<i>Applicant:</i>	Rowley	<i>Examiner:</i>	Nicholson, Erick
<i>Serial #:</i>	09/682,467	<i>Art Unit:</i>	3679
<i>Filing Date:</i>	06 September 2001	<i>Date:</i>	8 May 2003
<i>Title:</i>	Bendable Polymer-Lined Water Heater Connector

Version with Markings to Show Changes Made

FIG. 5

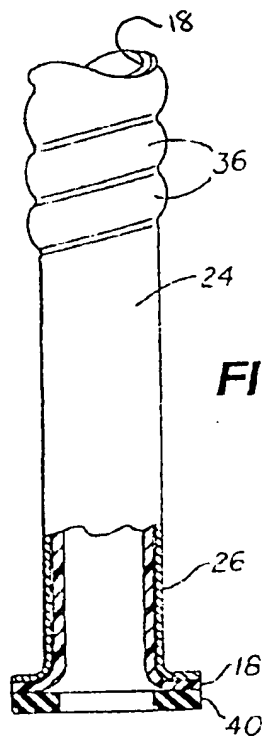
The examiner has indicated that the drawings are objected to in that the "inner polymeric liner conforming to the ribbed segment is not shown." Applicant's attorney would respectfully request the examiner to revisit this position in light of the addition made to FIG. 5 which adds the reference number 18 to a partial cut-away portion of the ribbed segment 36 clearly showing the inner polymeric liner conforming to the ribbed segment. The applicant's attorney requests that the examiner approve this change, which is submitted in red.
